Informal document **GRVA-01-30**

1st GRVA, 25-28 September 2018

Modifications to UN R131 AEBS for Heavy Vehicles

Explanation of ECE/TRANS/WP.29/GRVA/2018/4
at the 1st GRVA

Warning

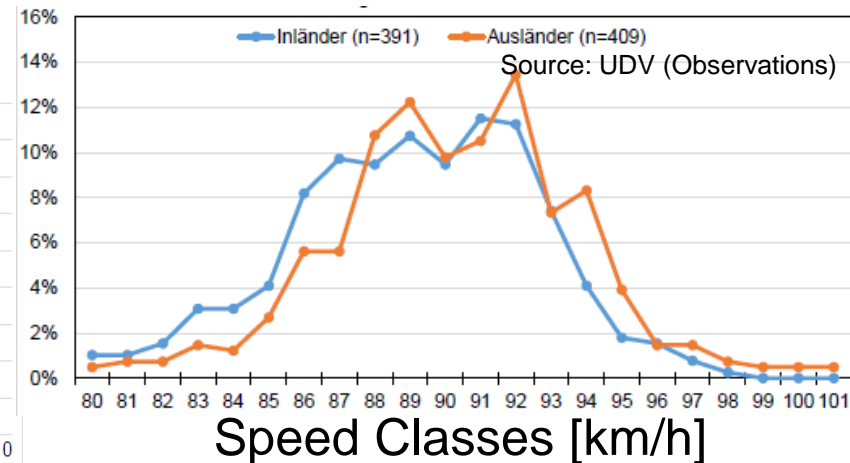
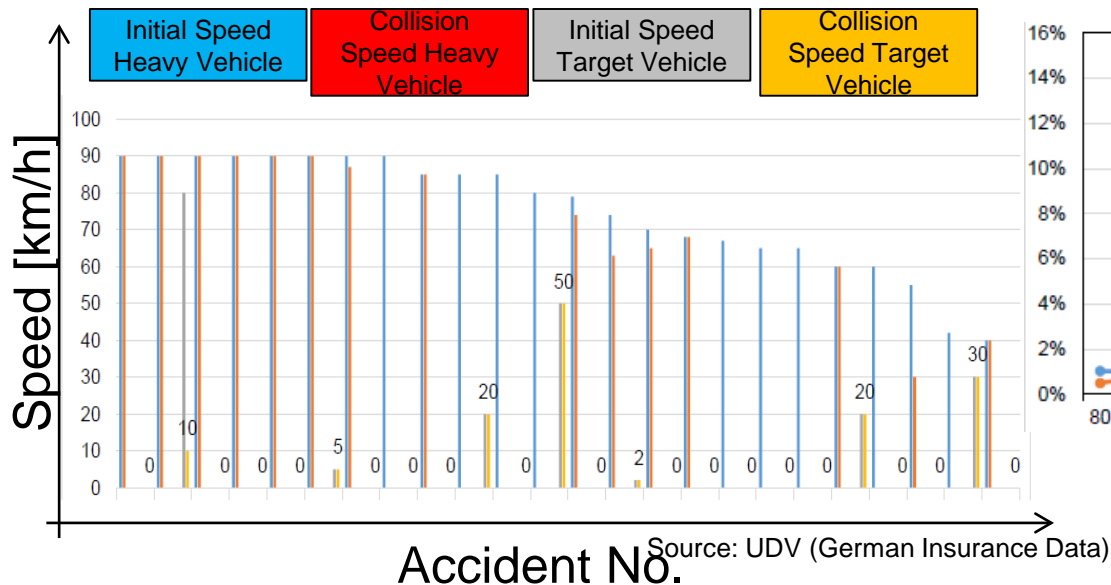
- Current warning requirements: too frequent warnings in certain situations
 - Low speeds: Manual brake application in regular situations late
 - Warning required 1.4 seconds before emergency brake phase → long before manual brake application!
- Current warning requirements prevent effective braking e.g. for decelerating lead vehicles
 - Minimum warning time of 1.4 seconds (0.8 s for lighter vehicles) before full braking can be applied
 - Speed reduction in warning phase is limited
- **Conclusion: Speed reduction/deceleration constraints for warning phase need to be removed for efficient braking!**

Performance Requirements (Speeds in km/h)

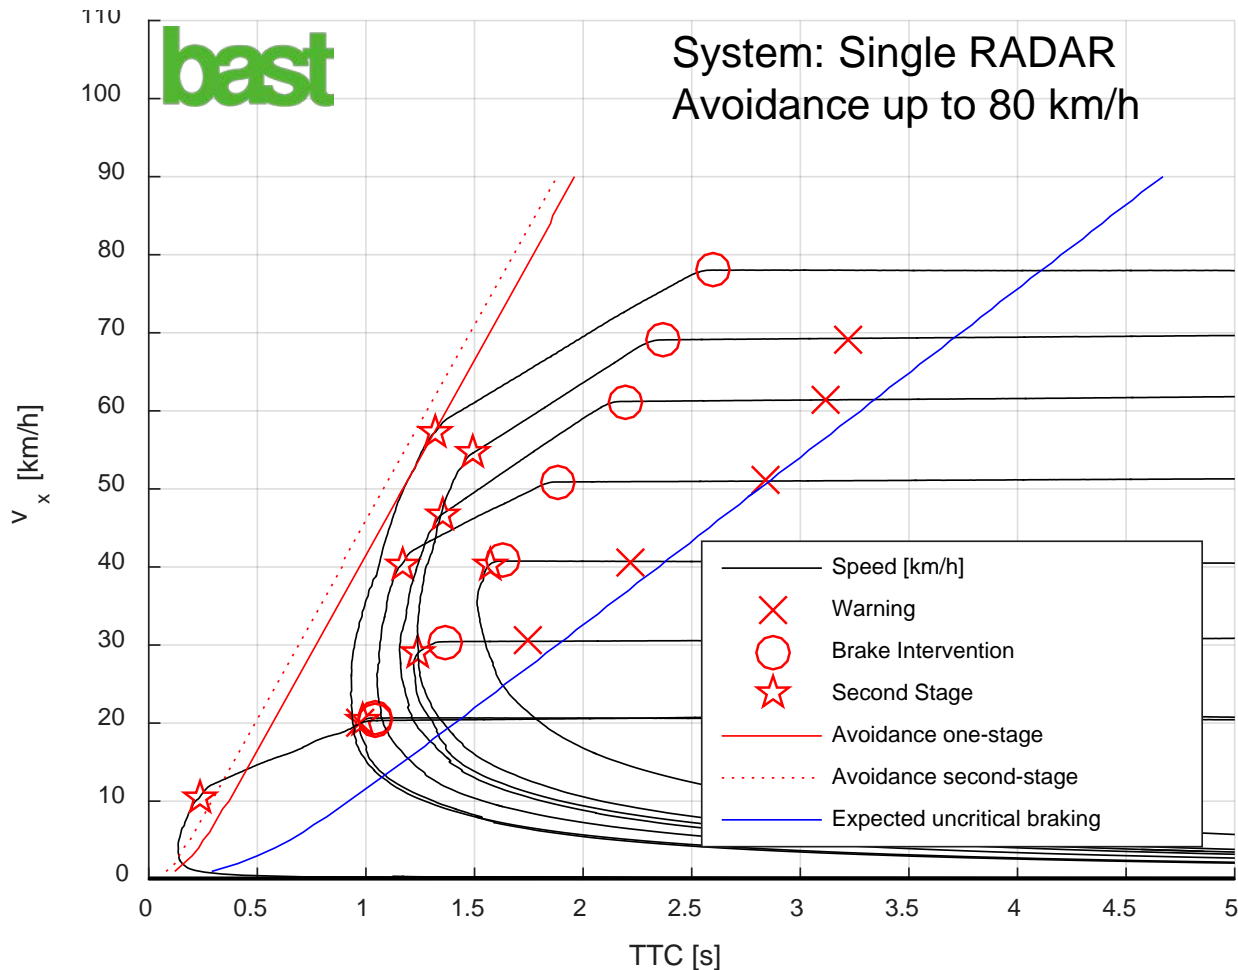
- 70 km/h relative speed reduction already required for moving vehicles
- Now: require this also for stationary vehicles

Stationary Vehicles	Constant Moving Vehicles	Proposal
N2*, M2* (current R131)	$v_{\text{red}} = 10$	$v_{\text{red}} = 12$	$v_{\text{rel,avoid}} = 70$ $v_{\text{rel,red,mitig.}} = f(v_{\text{rel}})$
N3**, M3** (current R131)	$v_{\text{red}} = 20$	$v_{\text{red}} = 68$	$v_{\text{rel,avoid}} = 70$ $v_{\text{rel,red,mitig.}} = f(v_{\text{rel}})$
Test Speeds	80	$v_{\text{Ego}} 80,$ $v_{\text{Target}} 12 (N3),$ $v_{\text{Target}} 68 (N2^*)$	To be selected from whole operating speed range

Expected AEBS Performance as Function of Test Speed

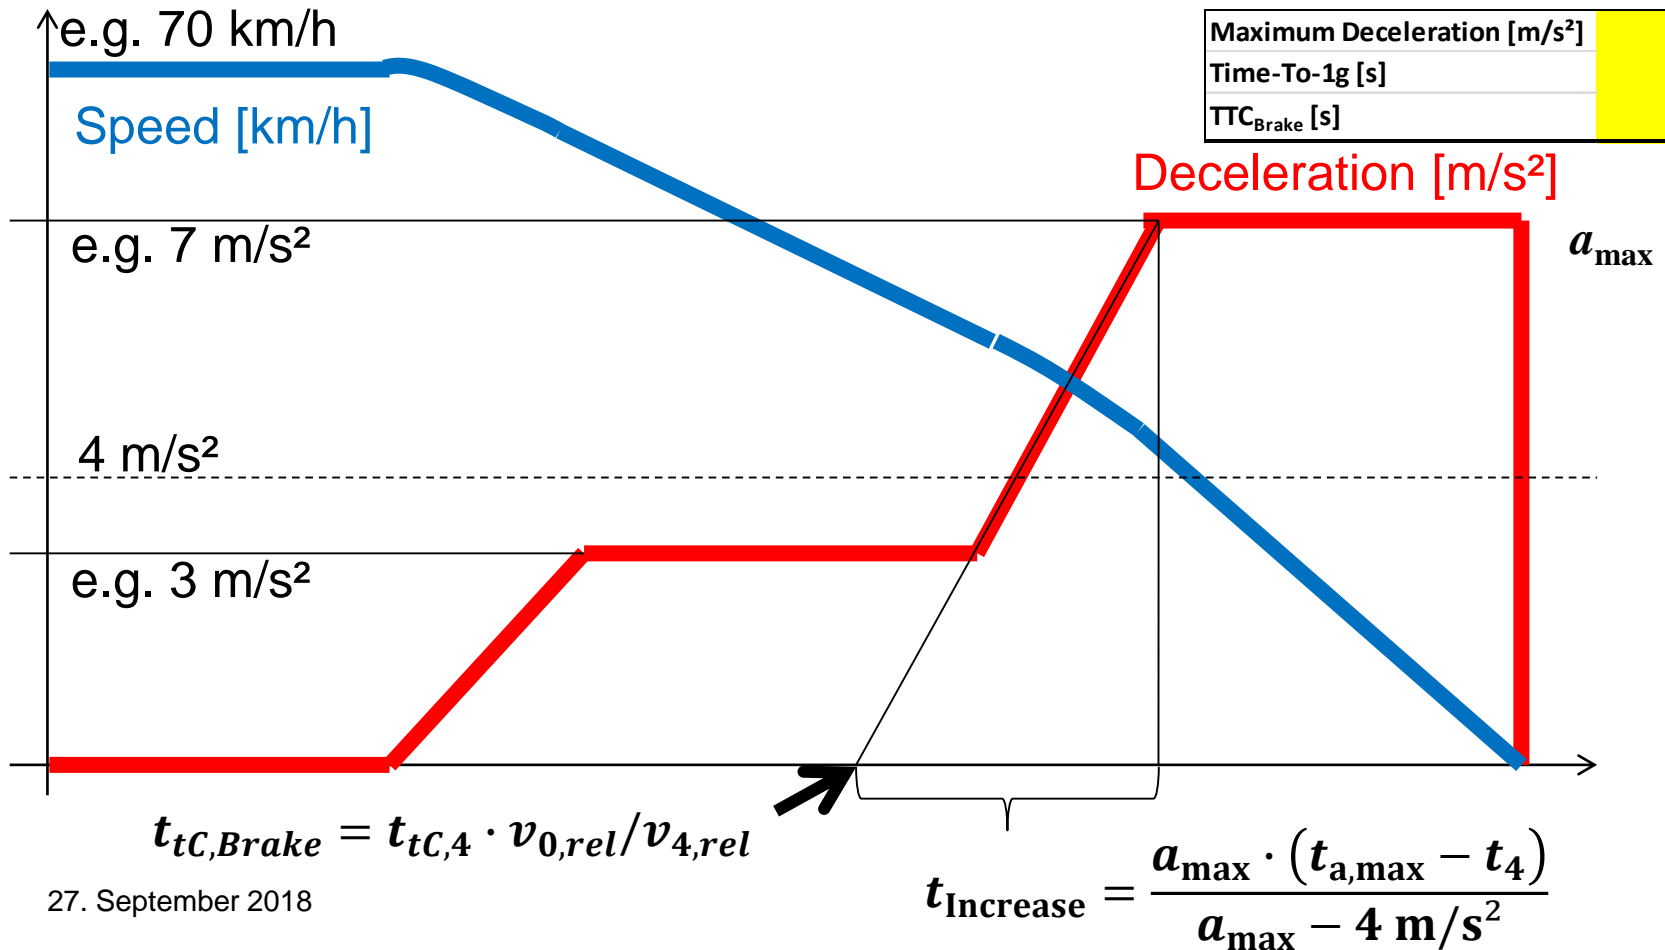
Example: Required Performance

Test Speed [km/h]	Speed Reduction [km/h]	Impact Speed [km/h]
10	10,00	0,00
20	20,00	0,00
30	30,00	0,00
40	40,00	0,00
50	50,00	0,00
60	60,00	0,00
70	70,00	0,00
80	57,16	22,84
90	51,36	38,64
100	48,34	51,66
110	46,32	63,68
